To: Mike Morden, Gibson Energy
Bill Frerking, USD Group

From: Damien Hocking, Corelium Software

Re: Operational Value Chain Carbon Emissions Model Review - Summary

Figure 1

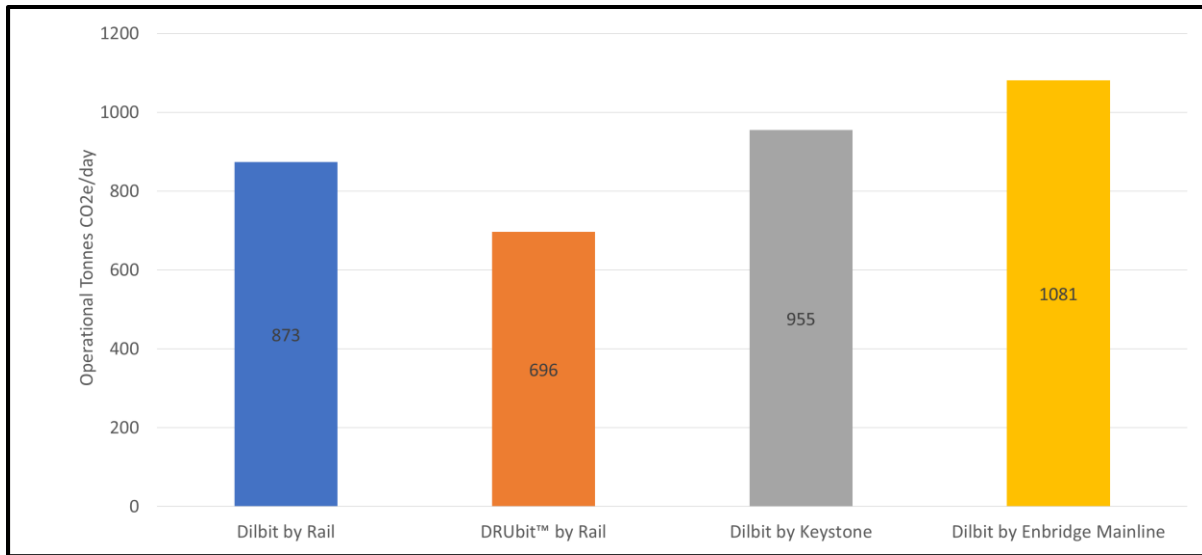
The model indicates that the DRUbit™ scenario above saves between 20% – 36% of operational CO_{2e} emissions compared to the Dilbit rail and pipeline scenarios. Against the Dilbit by rail scenario, the model predicts that the DRUbit™ scenario saves approximately 63,000 metric tonnes CO_{2e}/year (20%, 69,000 U.S. tons/year). Against the Keystone scenario, the model predicts that the DRUbit™ scenario saves approximately 92,000 metric tonnes CO_{2e}/year (27%, 101,000 U.S. tons/year). Against the Mainline scenario, the model predicts that the DRUbit™ scenario saves approximately 137,000 metric tonnes CO_{2e}/year (36%, 151,000 U.S. tons/year).

These savings are achieved by removing the diluent required to enable pipeline transport and replacing those pipeline transport emissions with rail transport emissions. Diluent is recovered at the upstream HET location instead of the downstream end-user refinery, removing the diluent transport loop and associated emissions. A comparison of the predicted total emissions for each scenario is shown in Figure 1 below.
